Display

Subject: **CORRECTING RINGING AT TOP OF PICTURE**

Model: **BVM-14E1U, BVM-14E5U, BVM-14F1U**
BVM-14F5U, BVM-20E1U, BVM-20F1U

Figure 1

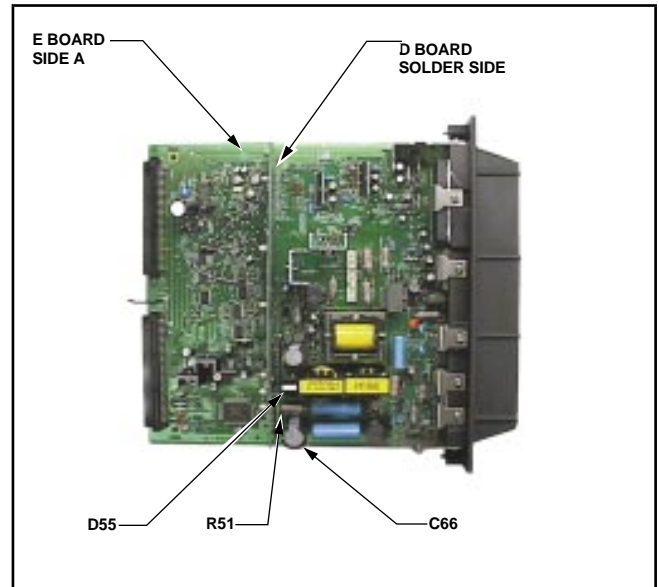
E Board (Side A)
 (See Figure 1.)

1. Remove D board.
2. Remove resistor R51 and diode D55 (zone B-11).

Figure 2

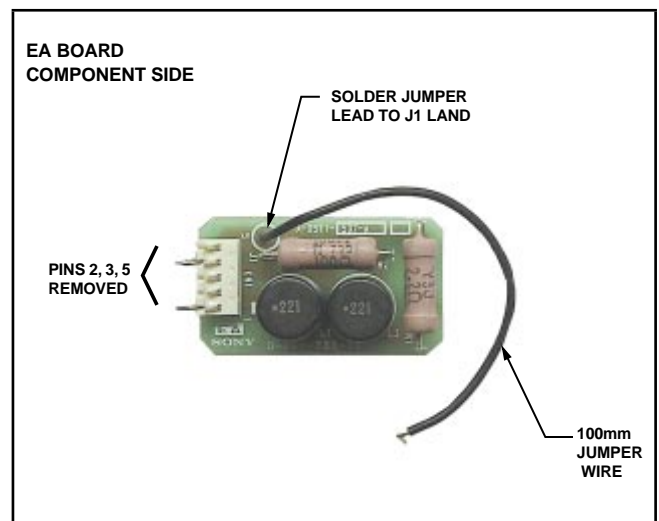
EA Board (Component Side)
 (See Figure 2.)

3. Cut pins 2, 3 and 5 of connector CN1.
4. Solder one lead of 100mm jumper wire to J1 land.

5. Trim all leads of components to less than 1mm, to prevent contact with other components when board is installed on E board.

Figure 3

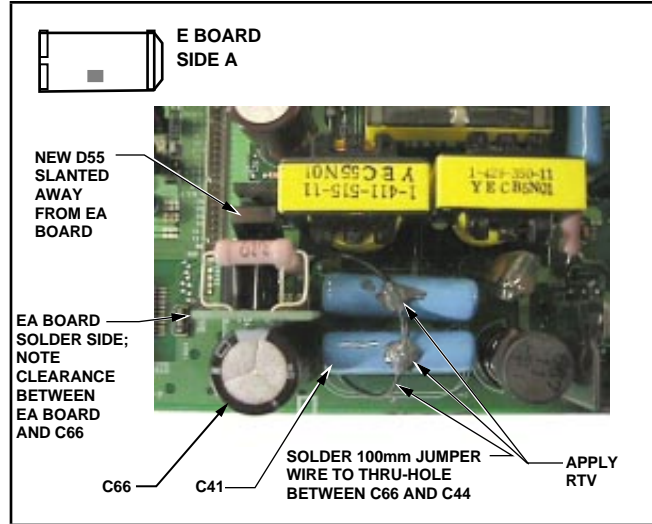
E Board (Side A, Zone A/B-11)
(See Figures 3 and 4.)

6. Install new diode D55 in location of former part, which was removed in step 2 above.

NOTE: Ensure that D55 is mounted at a slant as shown.

7. Install EA board in location of R51 which was removed in step 2 above.

NOTE: Ensure that EA board leads on solder side do not contact capacitor C66.

8. Insert and solder other lead of 100mm jumper wire on EA board in thru-hole between C66 and lead of C44 near C66.

9. Apply RTV as shown to secure jumper wire to E board.

Figure 5

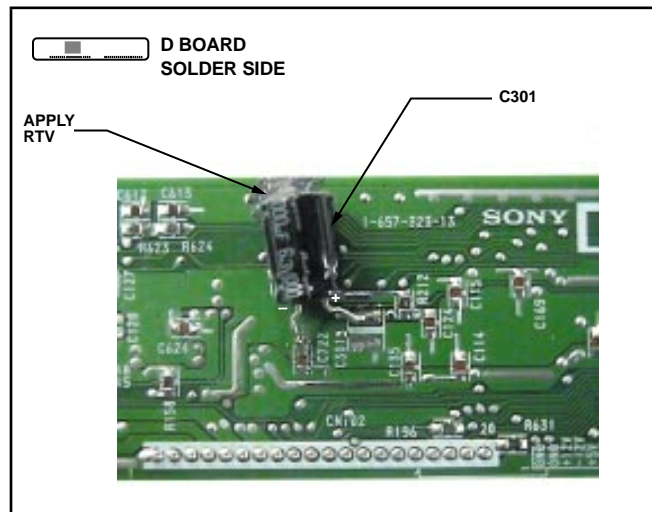
D Board (Solder Side)
(See Figure 5.)

10. Remove capacitor C301 (zone A-5) and resolder, repositioning it as shown.

11. Apply RTV as shown, to secure C301 to board.

Figure 6

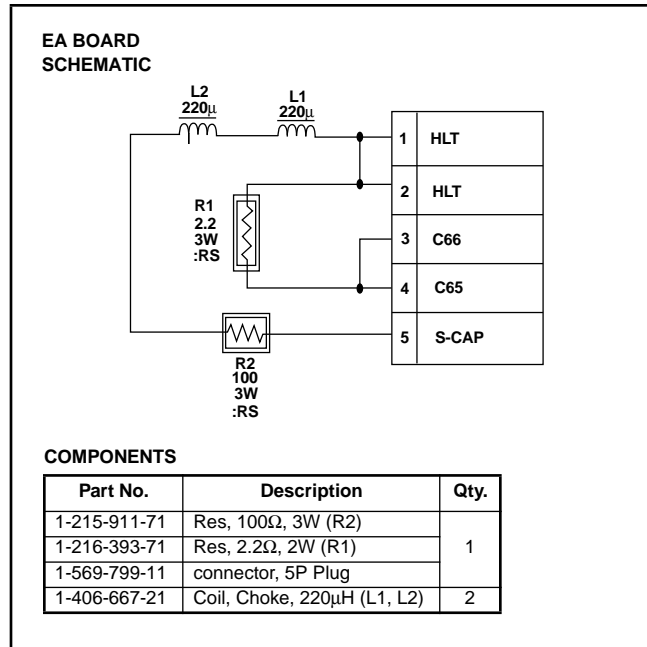
- EA board schematic is as shown in Figure 6.
- E board schematic has changed as shown in Figure 7, due to removal of R51 and addition of EA board.
